Technical Note 1: Rebuttal

Site: 40 – 42 South Street, Worthing
Prepared by: Laura Jagiela
Approved by: Phil Allen MCIWEM C.WEM
Date: 5th February 2026

1.1 This technical Note has been produced by Motion to discuss the EA's and WSP's comments relating to the Flood Risk Assessment (FRA) on planning application AWDM/1386/25, which relates to the proposed development at 40 – 42 South Street, Worthing, West Sussex.

EA Site Node Map

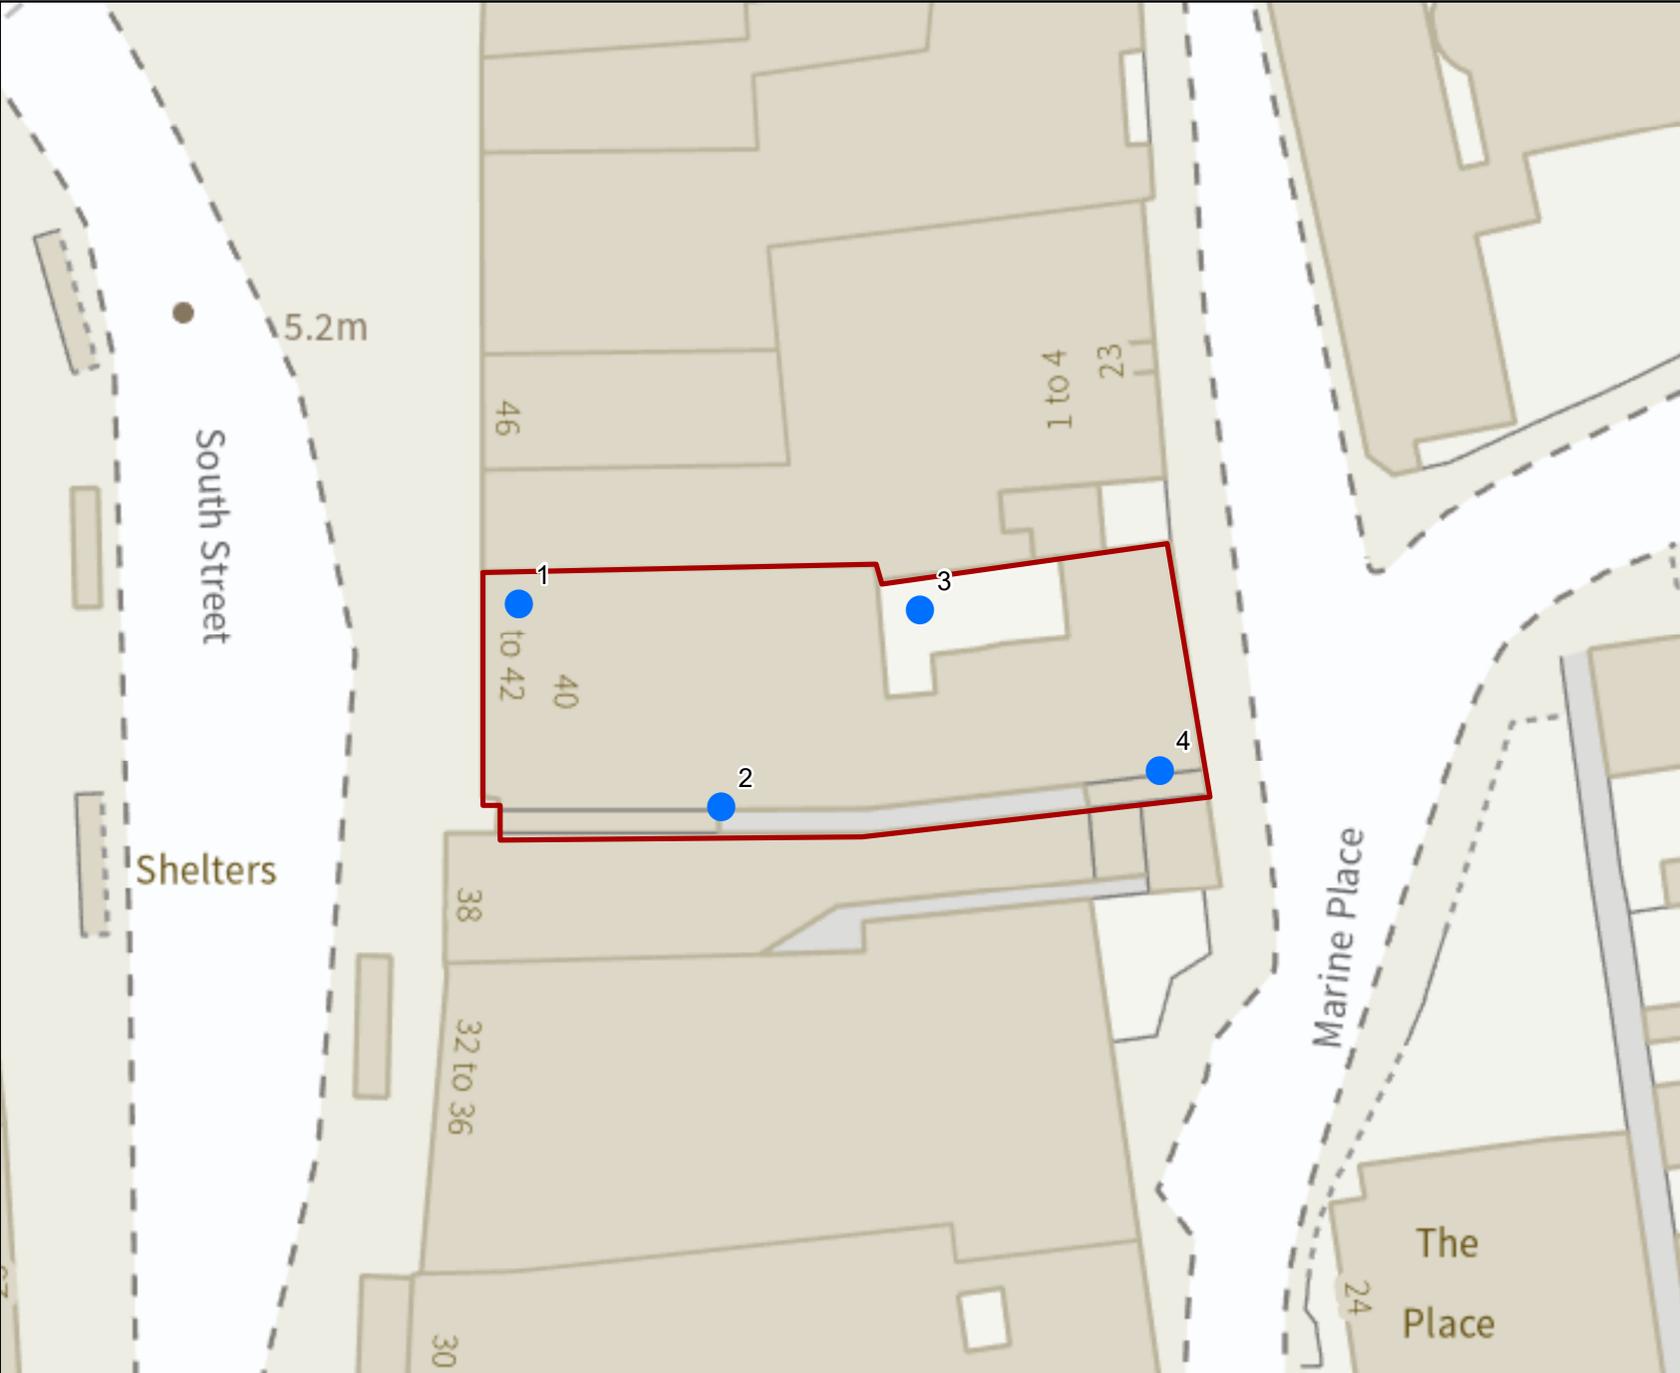
- 3.3 The tidal flood levels have been modelled and recorded for 4 nodes across the site. The location of these nodes can be seen in **Appendix A**. Nodes 1 and 2 are situated within the area of the existing commercial unit, while node 3 is positioned in the proposed courtyard and node 4 lies within the proposed ground floor dwelling.

- 3.4 The EA Product 4 Tidal Flood Levels and Depths can be seen in **Appendix B**. The EA tidal flood levels are not provided for all node locations, specifically for Nodes 3 and 4. This means that there is no flooding modelled in this location because the ground level is higher than predicted flood level. Therefore, this demonstrates that the area of the site where the proposed ground floor dwelling and courtyard will be located is not predicted to be at risk of flooding and, therefore, is in Flood Zone 1.

- 3.5 For Nodes 1 and 2, the highest tidal flood levels for the predicted future year 2115 1:200 tidal event is 5.26 mAOD.
- 3.6 As specified in the FRA, sections 4.10 to 4.11, the front of the building is situated at approximately 4.8 mAOD. Based on product 4 data, these areas may be subject to an estimated flood depth of up to 460 mm when compared to the projected highest tidal flood level for the year 2115 (1:200 tidal event), which is 5.26 mAOD. The rear of the building is positioned at approximately 5.8 mAOD, 540 mm above the maximum predicted level. This could be raised to 5.86 mAOD as the National Planning Policy Framework (NPPF) advises that finished floor levels should be constructed at least 600 mm above the estimated flood level. However, where there is a high degree of certainty in the flood level estimates, this requirement may be reduced to 300 mm. Therefore, the floor level of the rear of the building is appropriate.

- 4.2 The EA Product 4 flood risk data, indicates that while the front portion of the site (Nodes 1 and 2) may experience tidal flooding of up to 460 mm by 2115, the proposed ground floor dwelling and courtyard (Nodes 3 and 4) are not predicted to be at risk, as their ground levels exceed projected flood levels. The rear of the building, at approximately 5.8 mAOD, is situated well above the anticipated maximum flood level, and the proposed finished floor levels are considered appropriate in this context.
